APPENDIX C

Agency Correspondence

Re: *Benton Solar Energy Project, Benton County, Minnesota*

Proposed Benton Solar with Public Waters

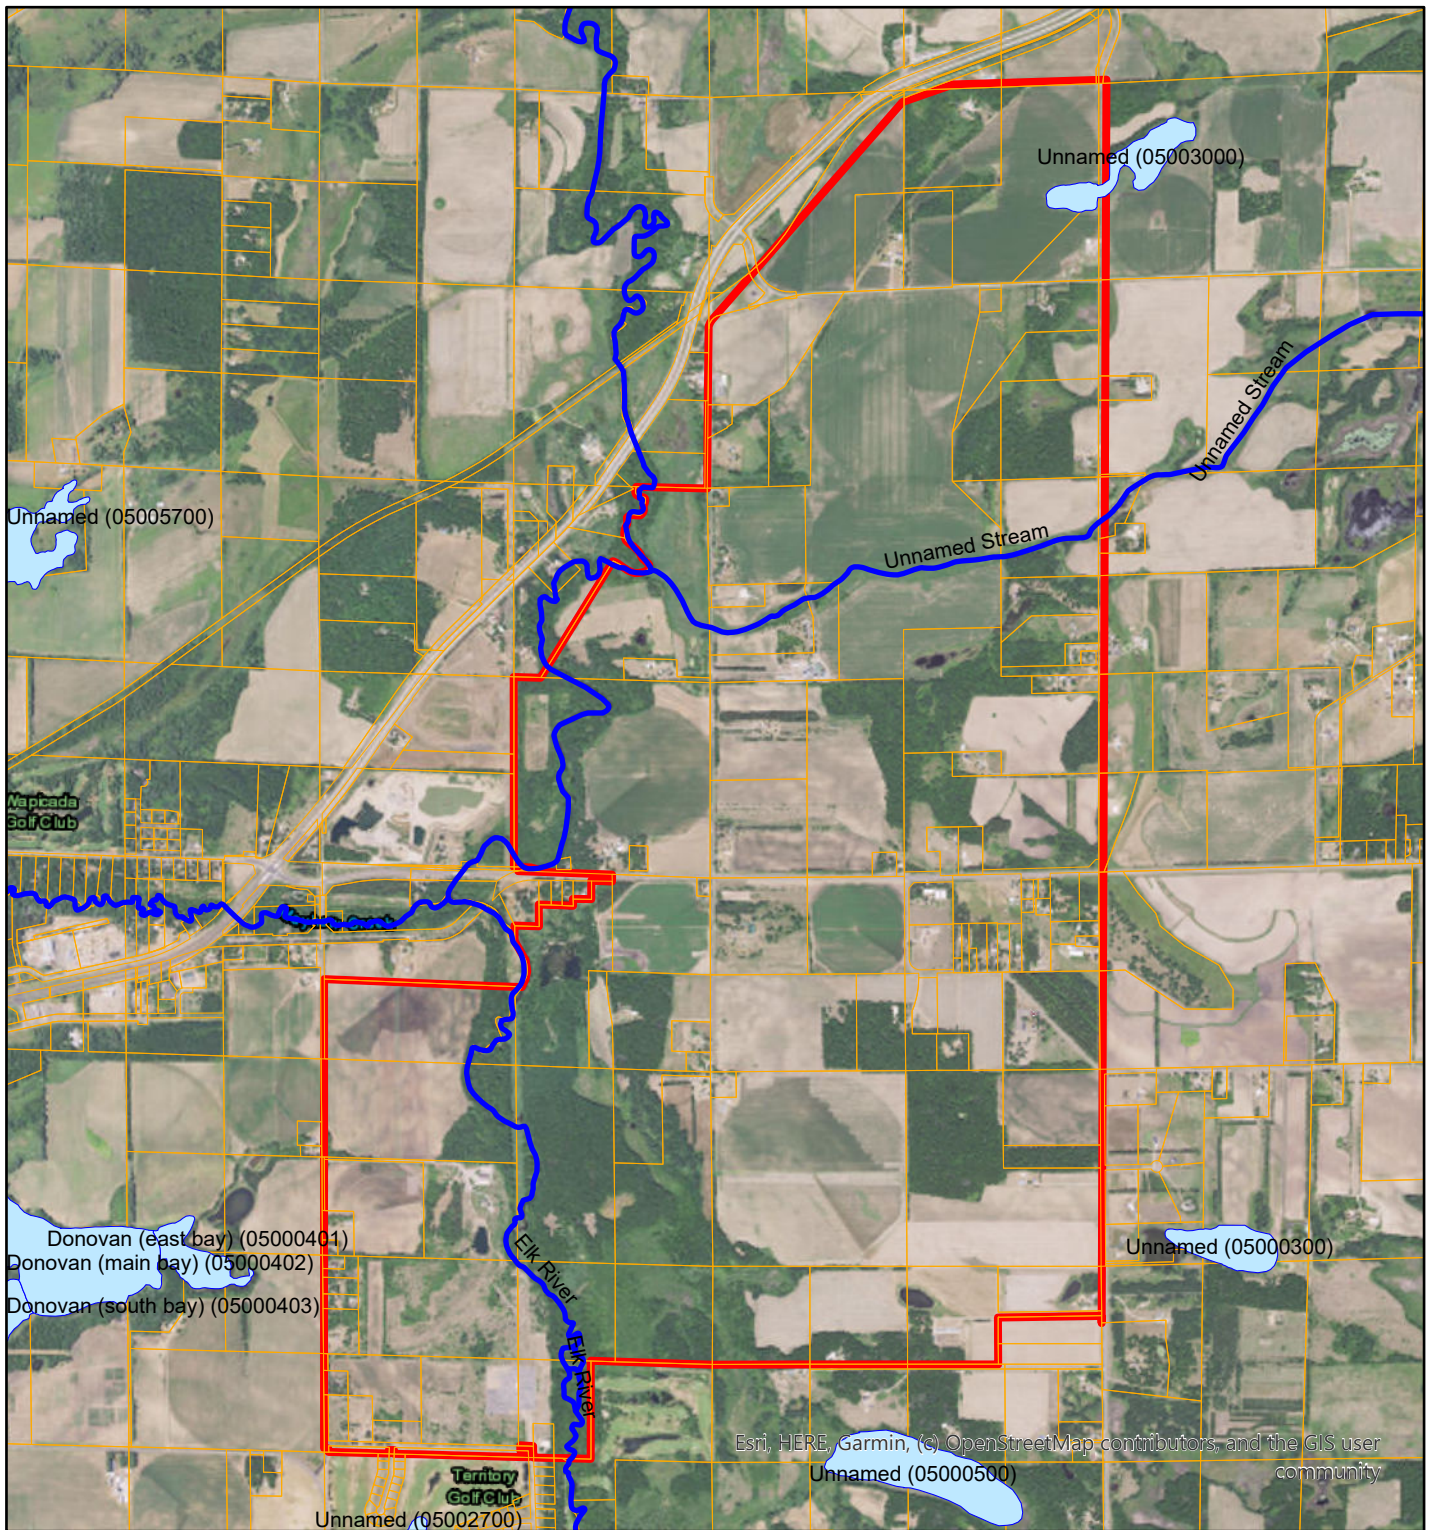
Also, there is not enough or the right type of information to allow us to pre-review the proposal as provided. There is no information on where the infrastructure is going to be or how power will be routed off the site, therefore, I don't know if you will need to apply for utility crossing licenses or not.

I am attaching a map that reflects the outline of the 3,000-plus acres you are indicating as the project area, along with an overlay three public watercourses within the area, and one or two lakes. If there are crossings of any of these watercourses, utility licenses will be required.
